READING BOROUGH COUNCIL

REPORT BY HEAD OF ECONOMIC & CULTURAL DEVELOPMENT

TO:	MAPLEDURHAM PLAYING FIELDS TRUSTEES SUB-COMMITTEE		
DATE:	30 JANUARY 2018		
TITLE:	MAPLEDURHAM PLAYING FIELDS LANDSCAPE UPDATE (amended 25/1/19)		
LEAD COUNCILLORS:	COUNCILLOR EDWARDS	PORTFOLIO:	MAPLEDURHAM PLAYING FIELDS CHAIR OF TRUSTEES
SERVICE:	TRUSTEE OF CHARITY	WARDS:	MAPLEDURHAM
LEAD OFFICER:	BEN STANESBY	TEL:	0118 937 3276
JOB TITLE:	LEISURE AND RECREATION MANAGER	E-MAIL:	ben.stanesby@reading.gov.uk

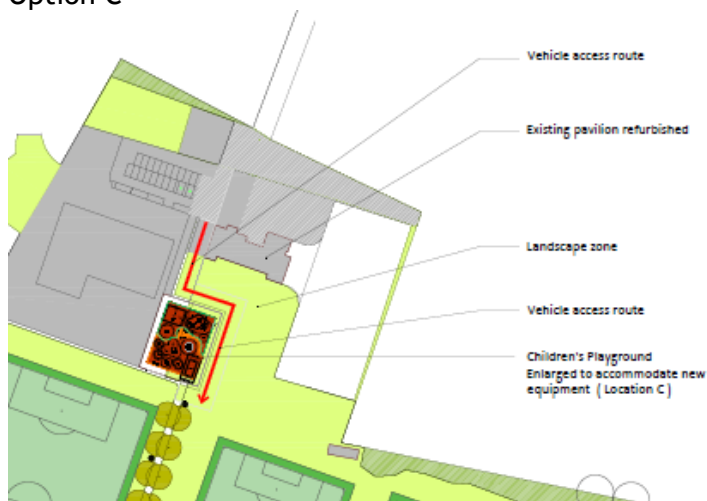
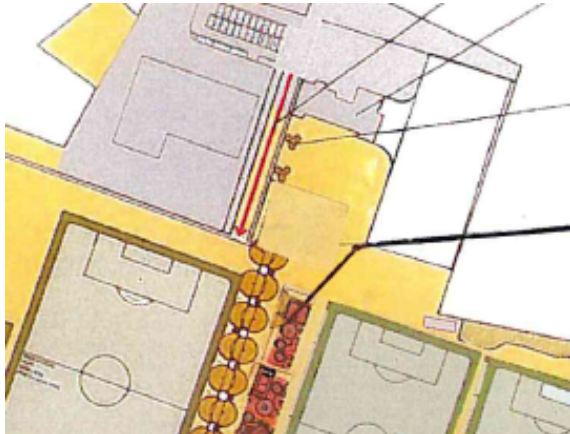
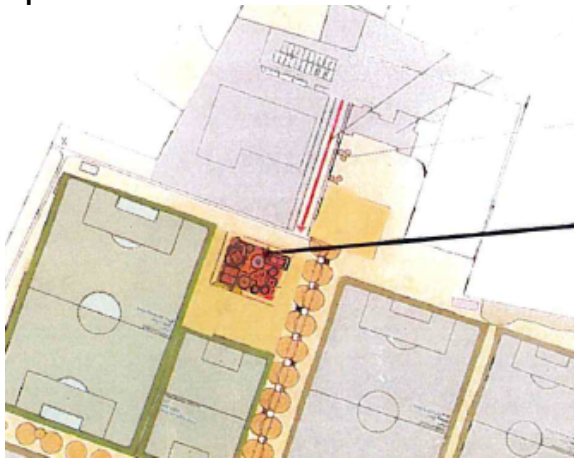
Option A

Advantages

- a) Maintains open views from the pavilion into and across the fields. (WADRA have expressed strong concerns that not having this will limit the ability to host wedding and other similar activities in the pavilion).
- b) Can utilise the space behind the pavilion for formal play/activities
- c) During events a continuous and interrupted piece of open space flows from the pavilion into the playing fields providing uninterrupted event space

Disadvantages

- a) A minimum recommended distance (buffer zone) from a large play area (NEAP) to the nearest property boundary is 30m. This standard is identified by Fields in Trust and adopted by the Council. This buffer zone is not achieved using location A. There is a risk that if noise nuisance were encountered the play area would need to be moved.
- b) Negative evaluation by environmental health (noise) during the planning process is

- c) There is a risk of the play area being used by young people in late evenings resulting in disturbance to neighbouring properties if youths congregate in the play area
- d) Slight cost increase to provide extended path to play area.
- e) Close proximity likely to introduce conflicts with football pitch use to immediate south
- f) Least passing surveillance /policing by playing field users of the 3 options
- g) Longest distance from the parking area to walk with small children of the 3 options
- h) Potential disturbance to tennis players
- i) If desired further extension of the tennis courts to the south in the future would be constrained

Option B

Advantages

- a) Appropriate buffer zones to residential properties provided (reduced noise disruption)
- b) Proximity to car parking for parents with small children
- c) Proximity to the pavilion allowing use when the pavilion is hired out for family events or refreshments available
- d) Proximity to the school providing activity for use by siblings awaiting brothers/sisters at the end of the school day and after school use
- e) 'Contains' a garden area between the pavilion and the play area, which can be used for summer time events and included as an outdoor space attached to the pavilion for private hire
- f) Adjacent to main access into playing fields
- g) Visually attached to the public recreation facilities rather than to the school
- h) Allows direct vehicular access onto playing fields
- i) Close to Multi Use Games Area and tennis courts.

2.1 That the Landscape Master Plan be amended to:

- Move the sport pitch drainage to the eastern side of the axial footpath (see para. 4.4.2)
- Adopt the proposed design for the children's play area and locate it to the south of The Heights School, (option E in para. 4.6); if this location cannot be implemented to site the play area to the south of the pavilion (option B in para. 4.6)
- Retain the Lombardy poplars point as per para. 4.8
